ADDENDUM #1 - 6/24/2025
1. REVISED SHEETS: D-1, D-2, D-6, D-7, INT-2, INT-3, INT-7, P-1, P-2, P-4, P-6, U-1 - U-7, U-12, W-1, W-2, W-5 - W-7, E-1 - E-9, PM-8, X-15, AND X-16.

E. MAIN STREET & S. HANCOCK STREET
ASSESSMENT DISTRICT - 2025

CITY PROJECT NO. 15125
CONTRACT NO. 8784

15125
D-1

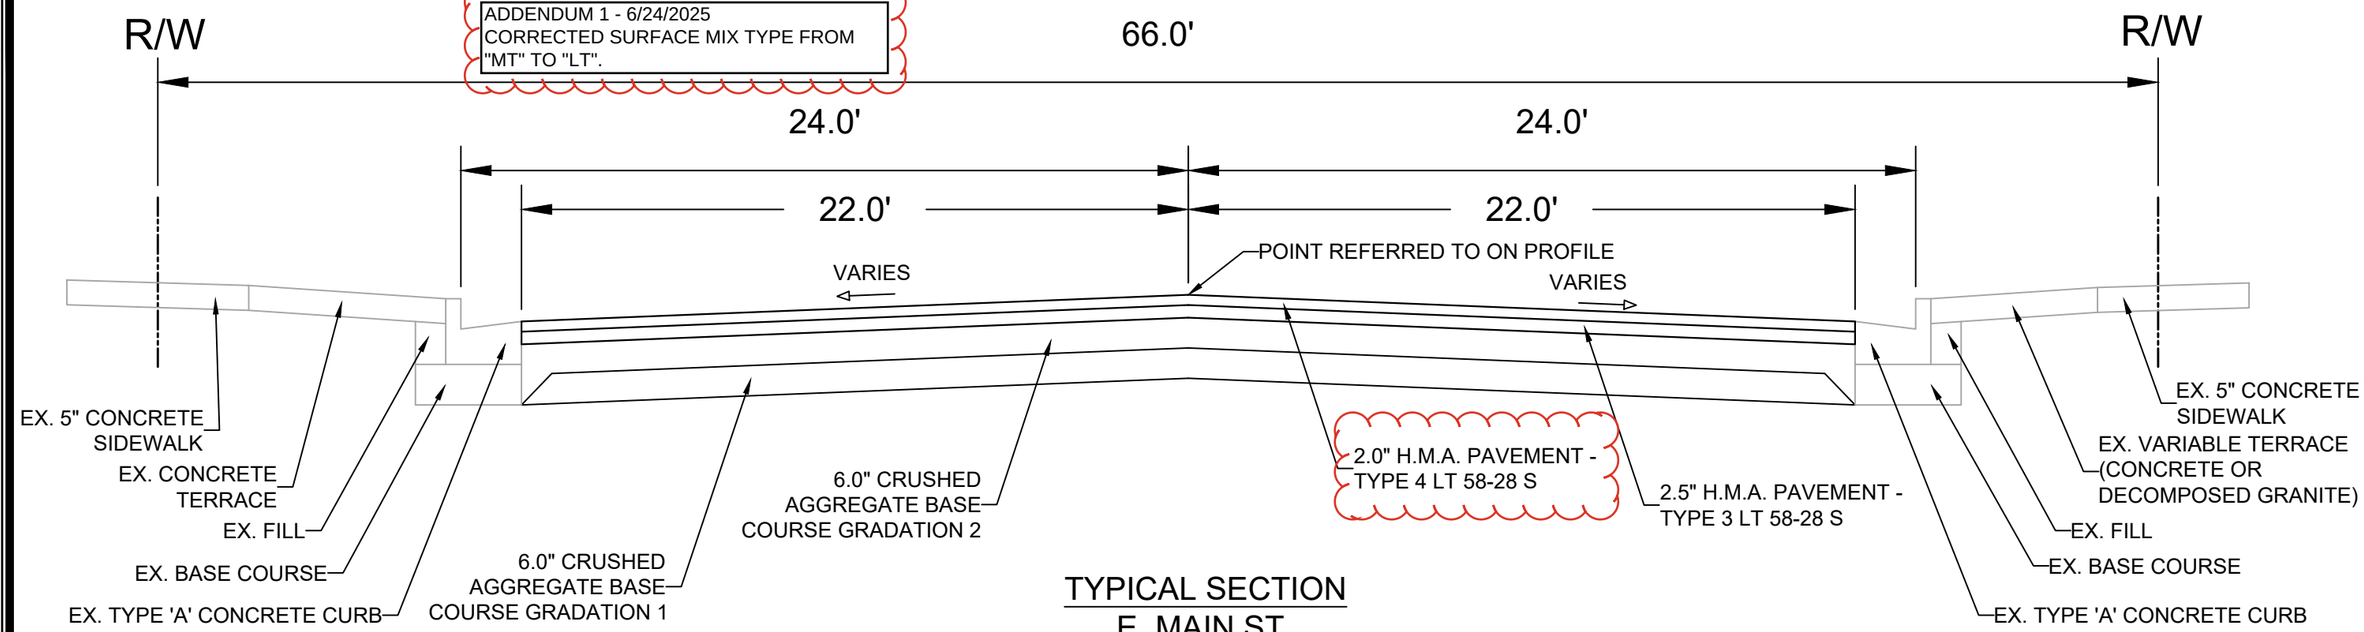
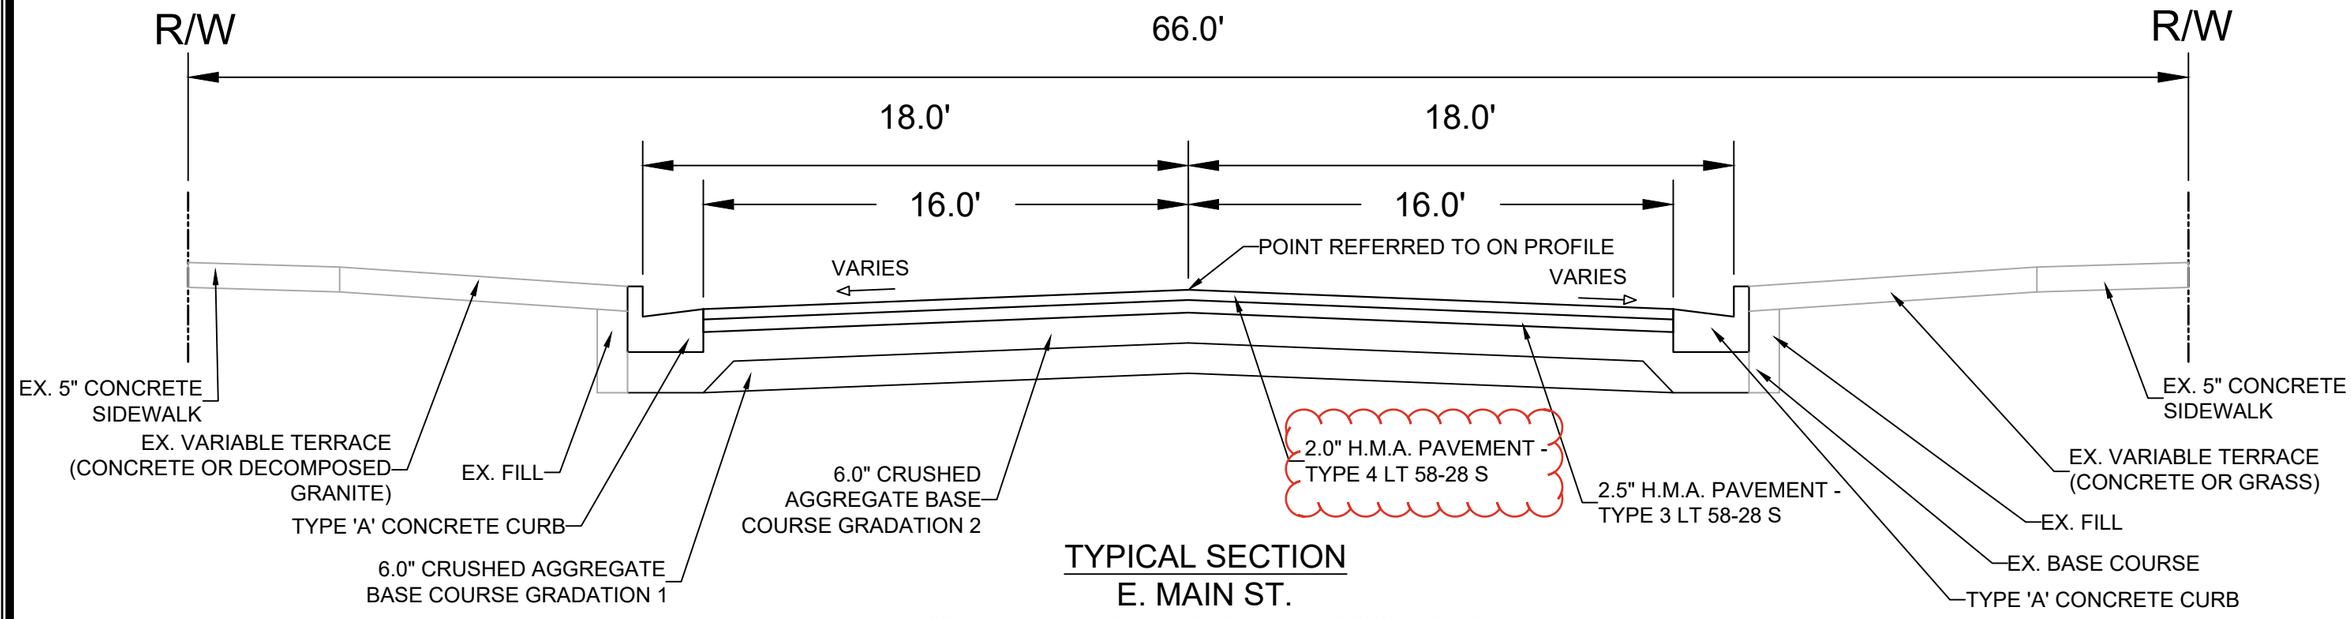
ADDENDUM 1 - 6/24/2025
CORRECTED SURFACE MIX TYPE FROM "MT" TO "LT".

15125
D-2

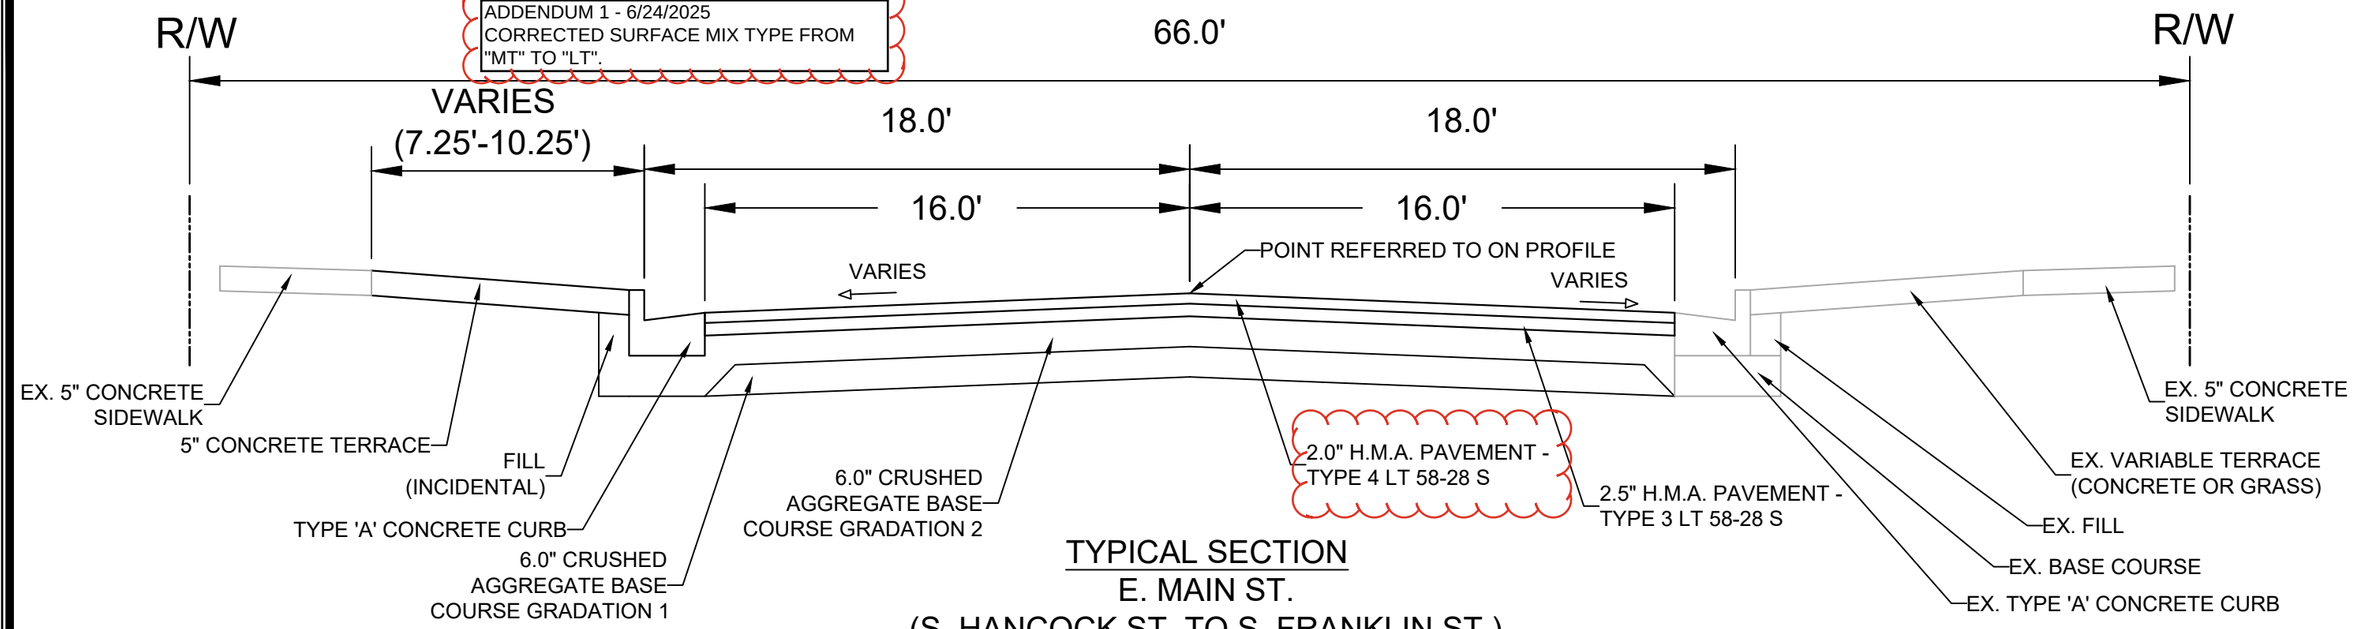
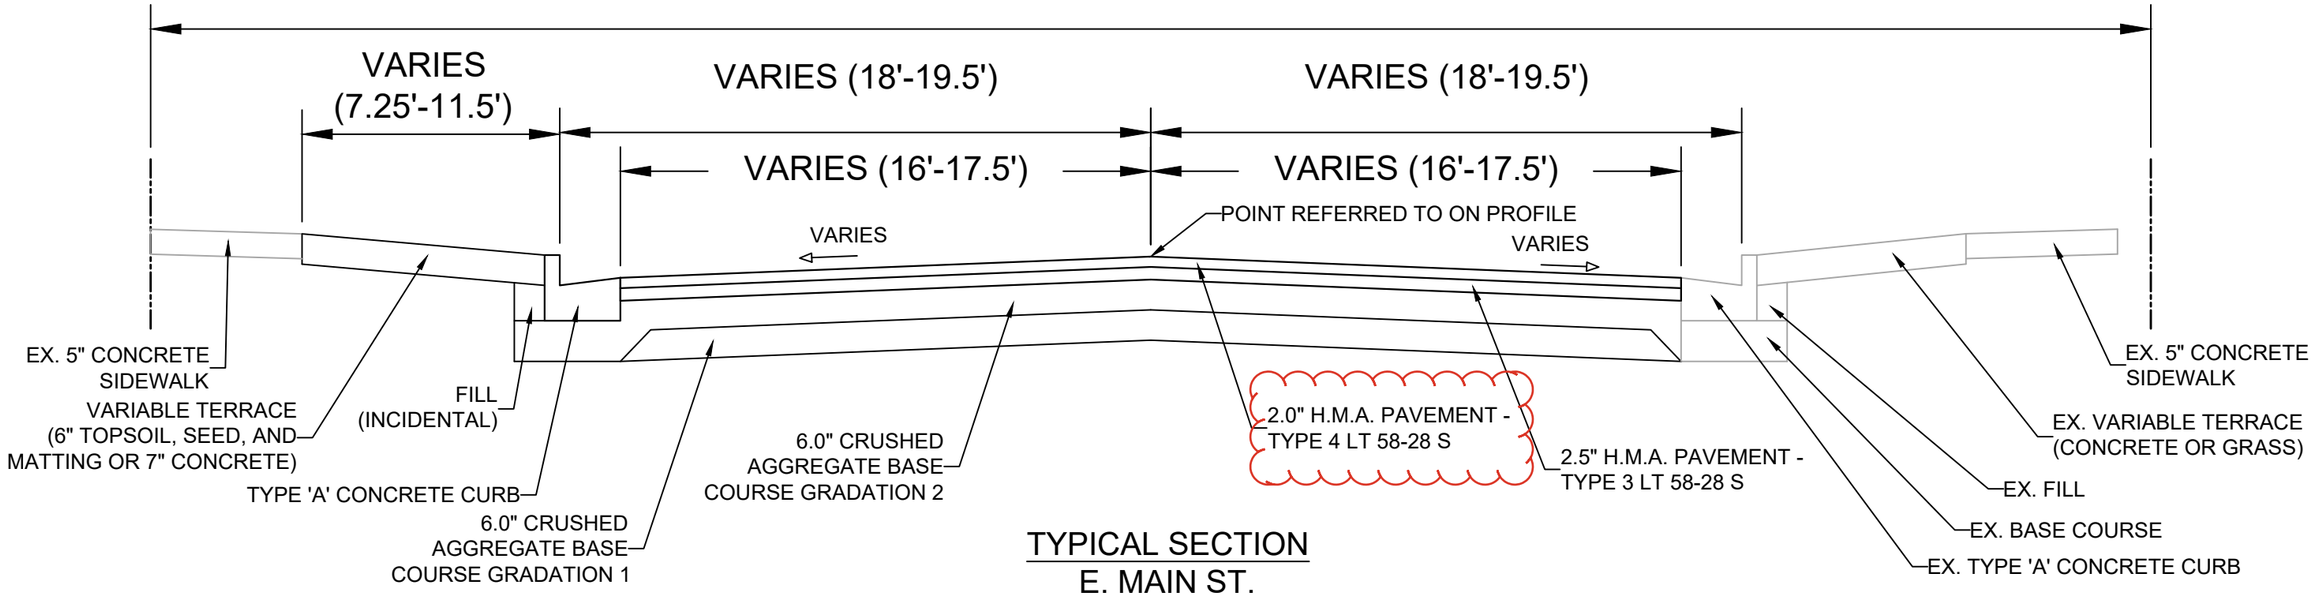
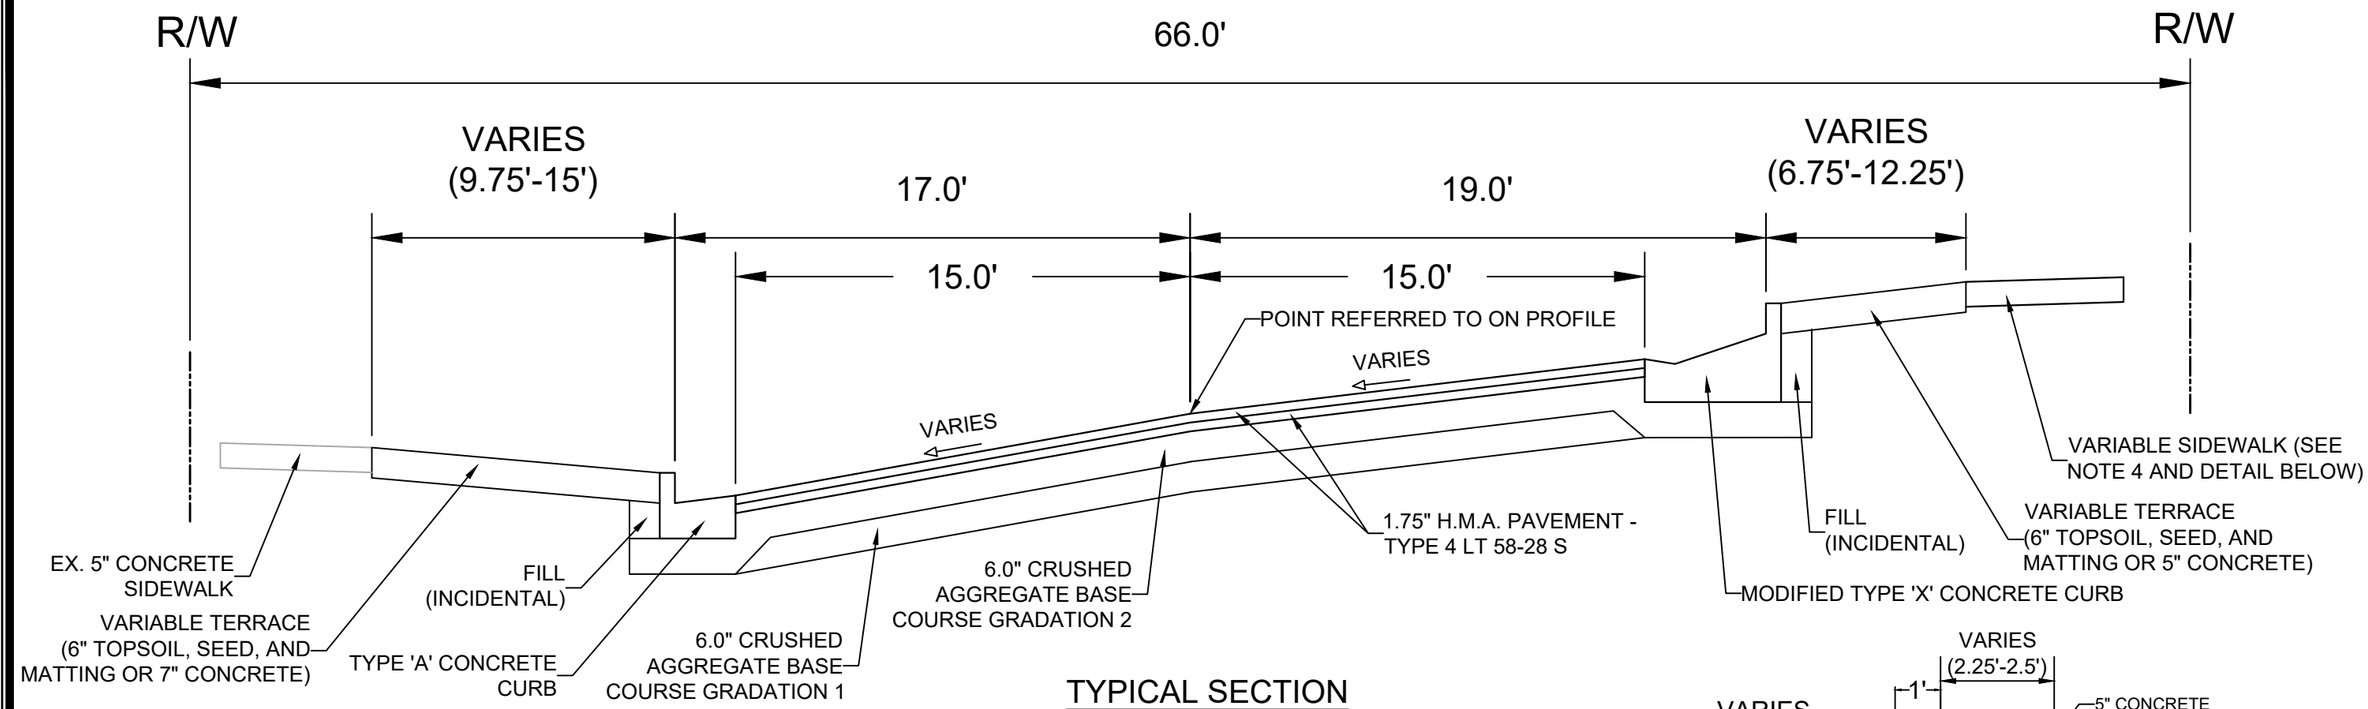
ADDENDUM 1 - 6/24/2025
CORRECTED SURFACE MIX TYPE FROM "MT" TO "LT".
